April 28, 2014

**RE: Comments on the Draft Supplemental Environmental Impact Statement “For The Leasing and Underground Mining of the Greens Hollow Federal Coal Lease Tract UTU-84102”**

Figure 2.2. Alternative 3.

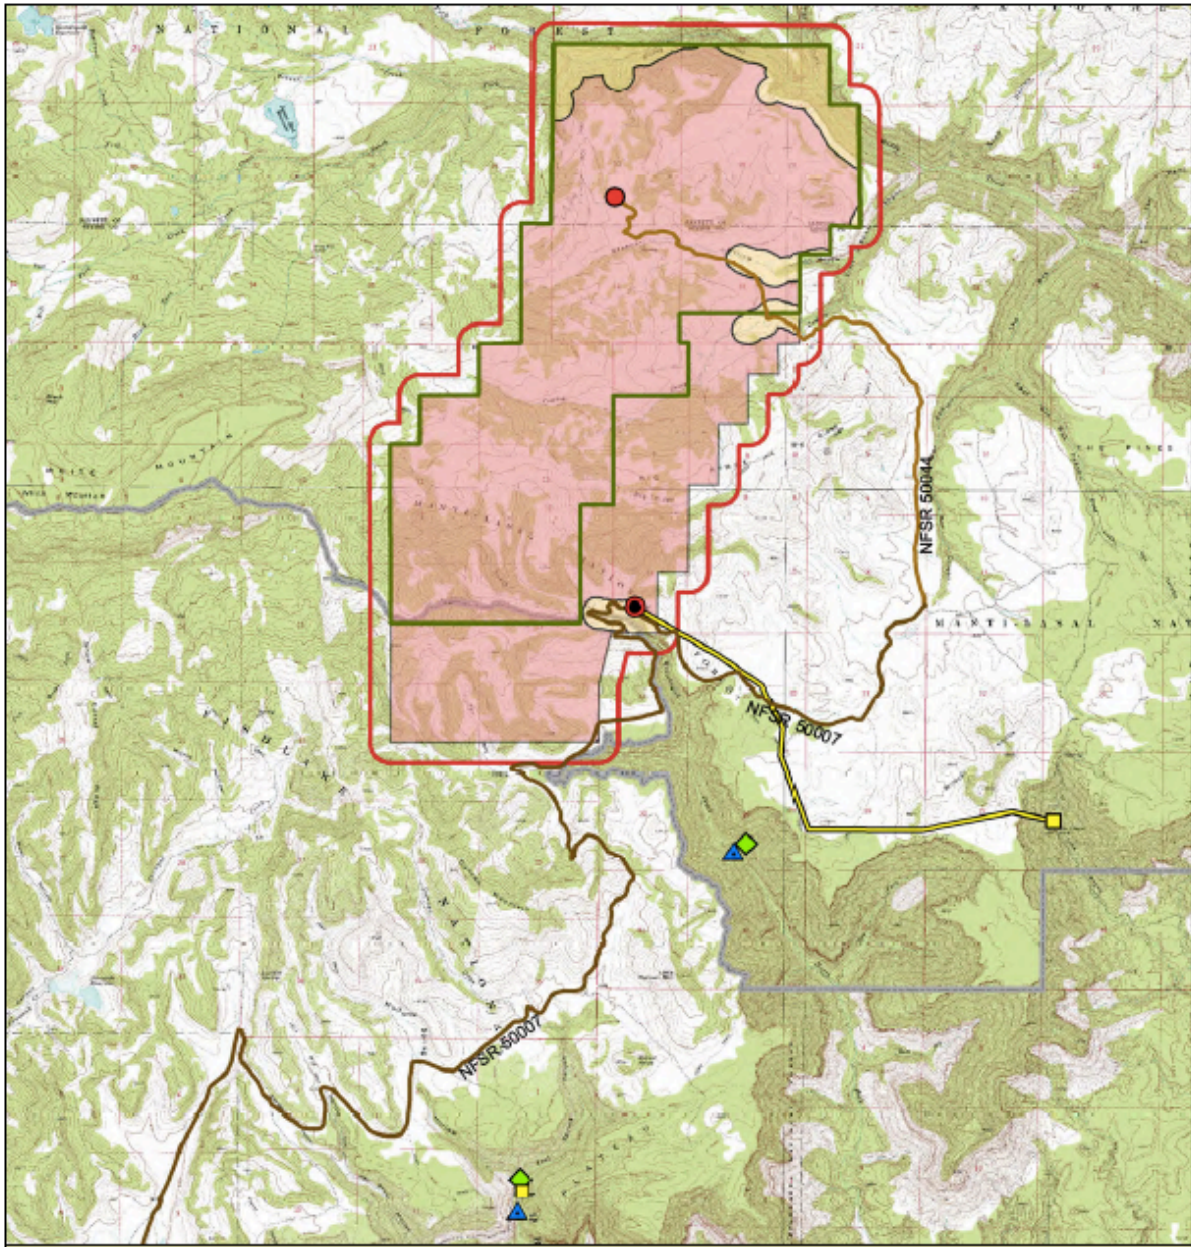
In the 2012 Final EIS for the Greens Hollow lease, the Agencies disclosed the likely location of proposed surface facilities, including a “conceptual northern vent shaft,” a “conceptual southern vent shaft and fan,” and a “conceptual power line route.” The map below, taken from page 20 of the Final EIS, displays the locations of these impacts. This map is significant because it indicates that the proposed vent shaft, vent shaft and fan, and power line route will directly impact priority sage grouse habitat and, it appears, the Wildcat Knoll lek.

Although these impacts were based on a “conceptual” plan, they reinforce the fact that the impacts of vent shaft construction, fan construction, and power line construction are reasonably foreseeable. Simply because these activities may occur in a slightly different location once the Greens Hollow lease is approved does not give the USFS and BLM license to refuse to analyze and assess the impacts to sage grouse associated with these surface activities. This is especially true where, as here, surface developments will be necessary to mine the Greens Hollow lease. To assert that such impacts are “unknown” or otherwise speculative is completely baseless. The DSEIS must be revised or supplemented to fully analyze and assess the potentially significant impacts of surface activities to sage grouse.

Figure 2.2. Alternative 3.

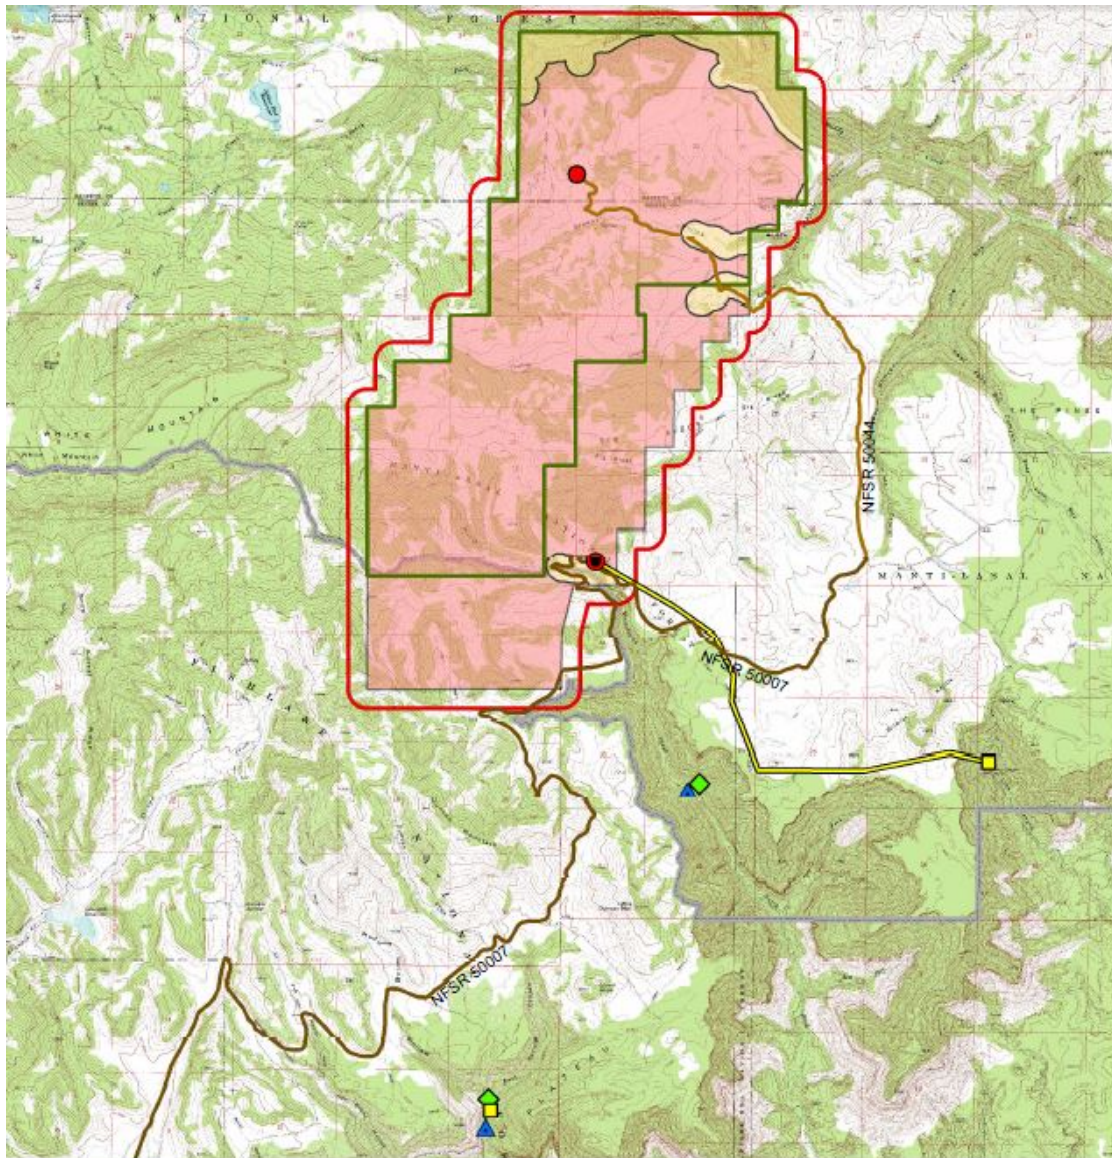
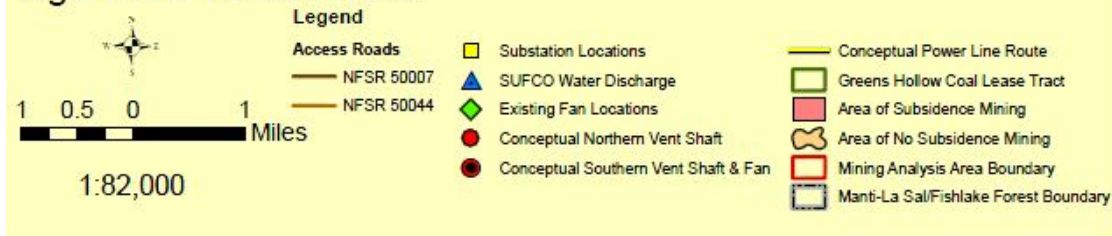
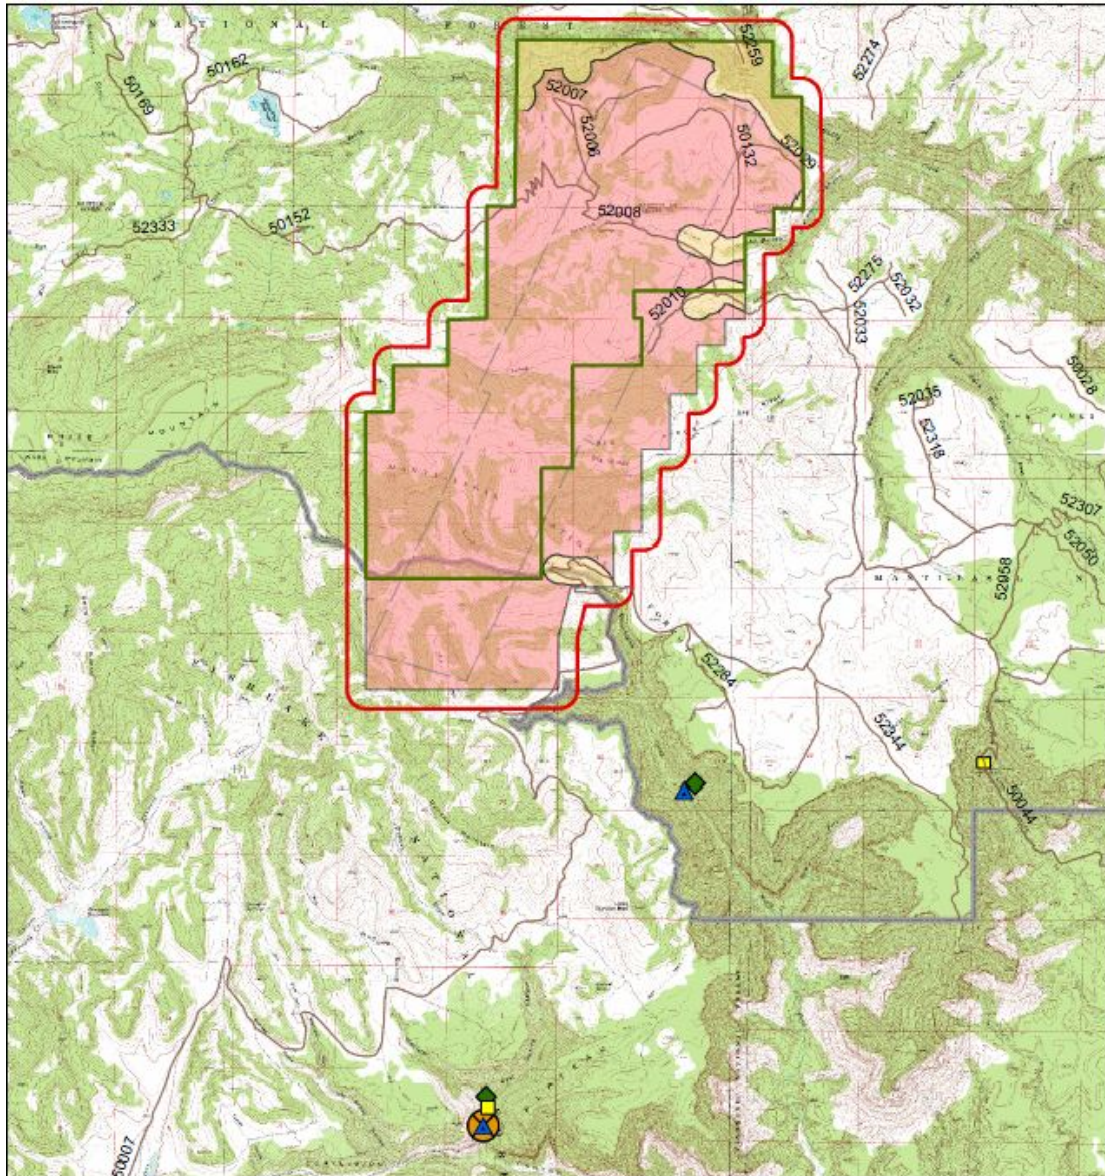
When one compares the FEIS and the DSEIS side-by-side or paragraph by paragraph, it becomes apparent that the DSEIS is a shortened and edited new iteration of the original EIS. Its analysis of impacts to surface resources is less site-specific than that found in the FEIS. It's a step in the wrong direction. A good example of how this happens is apparent in chapter 2 and the description of the Conceptual Mine Plan and Surface Use Scenario. This starts at section 2.5 of the FEIS, and section 2.6 of the DSEIS. There is no new site-specific disclosure of information in this part of the DSEIS. Instead, it reads as if it has been edited to remove the meaningful and important site-specific disclosures of what surface facilities would be required, and types of surface occupancy and access would be necessary to subsidence mine the area.

An easy way to see the nature of the omissions is by comparing the corresponding maps in the FEIS and the DSEIS for either action alternative, both of which are based on the same Conceptual Mine Plan. FEIS Chapter 2 has standard maps for both action alternatives, including the conceptual surface facilities that would be required, such as the 2 new vent fans and the new power line needed to power the huge fan needed for the southern vent fan. Chapter 2 of the DSEIS discloses that two vent fans would be required, and that one of them would need to have a huge fan that would need a new power line, but all attempts to disclose where the infrastructure would need to be located has been deleted. Consistent with this, Chapter 2 of the DSEIS has no maps for either action alternative. Instead, the maps for the action alternatives were scrubbed of site specific surface facilities and put in Chapter 1 of the DSEIS. Below, the FEIS alternative 3 map is compared with this scrubbed alternative 3 map from the DSEIS:

Note the site specific disclosure of the reasonably foreseeable new vent fans and the power line needed for the southern fan. The FEIS does not portend to propose approving these facilities, but correctly treats them as so obviously connected to and even triggered by either action alternative that they need to be analyzed site specifically now, in the EIS. Now, look to the DSEIS Chapter 1 map of the same action alternative:

is to review the DSEIS in a vacuum by itself one is led to the impression that it's simply not known where they may or may not be located. But they are known, and their site-specific location and proximity to resources studied in detail in the EIS is absolutely critical to the majority of the biggest impacts and resource conflicts central to this EIS process.
